SUBJECT: COMANCHE PEAK STEAM ELECTRIC STATION (CPSES), UNIT 2
DOCKET NO. 50-446
ADVANCE FSAR SUBMITTAL CONCERNING CHANGES TO THE
UNIT 2 INITIAL STARTUP TEST PROGRAM

ATTACHMENT 1 TO TXX-92146
SUMMARY OF CHANGES

ATTACHMENT 2 TO TXX-92146
DETAILED DESCRIPTION

ATTACHMENT 3 TO TXX-92146
MARKED-UP FSAR PAGES

FIGURE 14.2-4^B INITIAL STARTUP TEST SCHEDULE (UNIT 2)

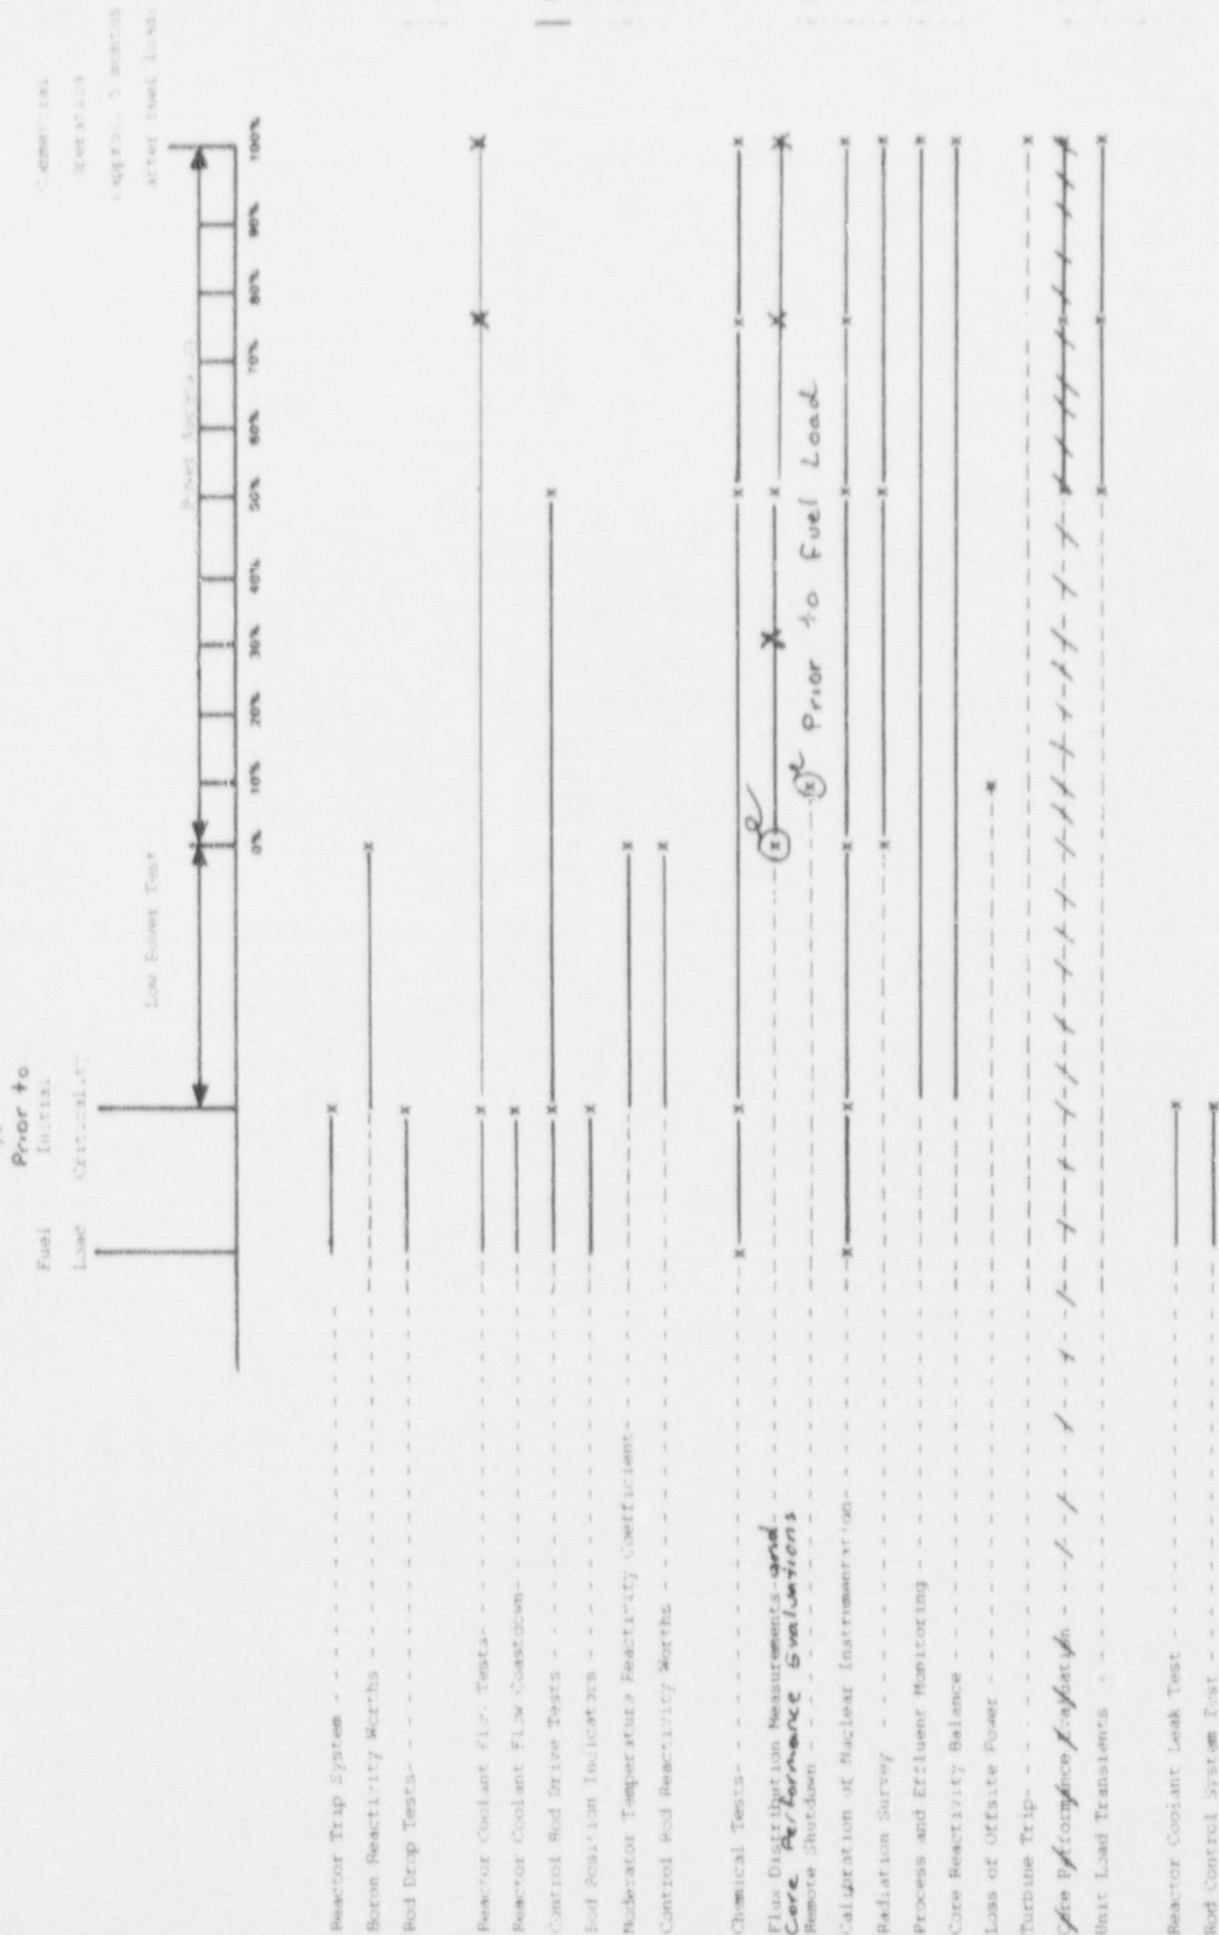
Figure 14.2-4B

- 2 Revises Unit 2 Initial Startup Test schedule to reflect changes proposed to the Reactor Coolant Flow Test (T14.2-3 Sheet 2), the Flux Distribution Measurements (T14.2-3 Sheet 20) and the Remote Shutdown Test (Table 14.2-3 Sheets 27 and 27a).
Revision:
See Descriptions provided for the above changes to Table 14.2-3.
Also editorially combines the Flux Distribution Measurements and the Core Performance Evaluation due to the overlap and similarity of the testing performed.
FSAR Change Request Number: 92-622.5
Related SER Section: 14.0; SSER23 14.0
